Frame Stage Inspection Report

77 Guroman Drive, Greenbank, Queensland, 4124 Australia

Frame Stage Inspection Report - SDA STAGE - Frame Stage Inspection Report 22 Apr 2025

Email address:	info@articon.com.au
Report Number:	ABI-02472
Inspection Date:	22 Apr 2025
Address of the Property Inspected:	77 Guroman Drive, Greenbank, Queensland, 4124 Australia

Photos of Defects

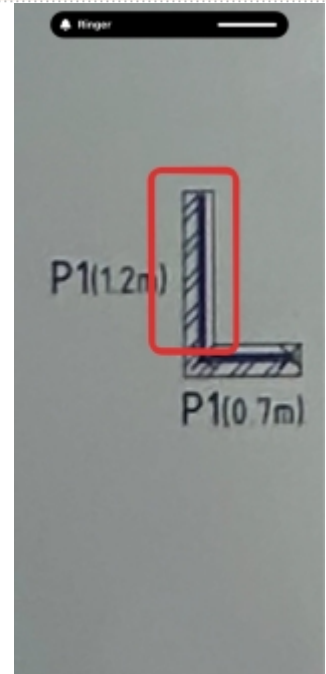
Missing playwood bracing to the master bedroom. Needs installing.

Photos of Defects

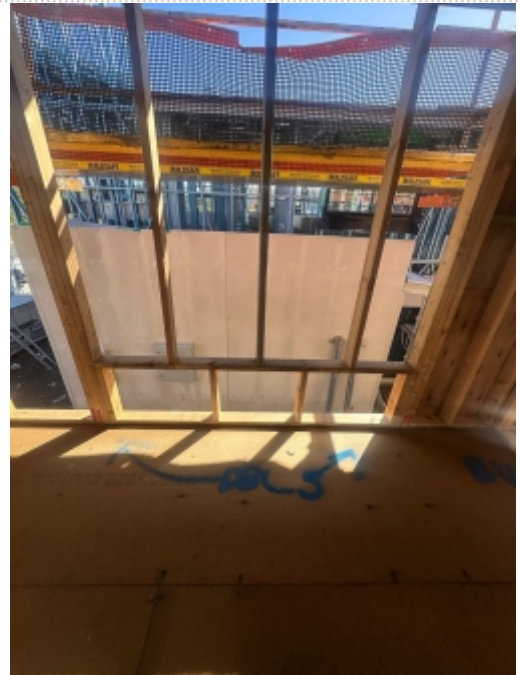
Missing tie-down rod to parts. Recommend engaging a qualified carpenter for future advice on rectification.
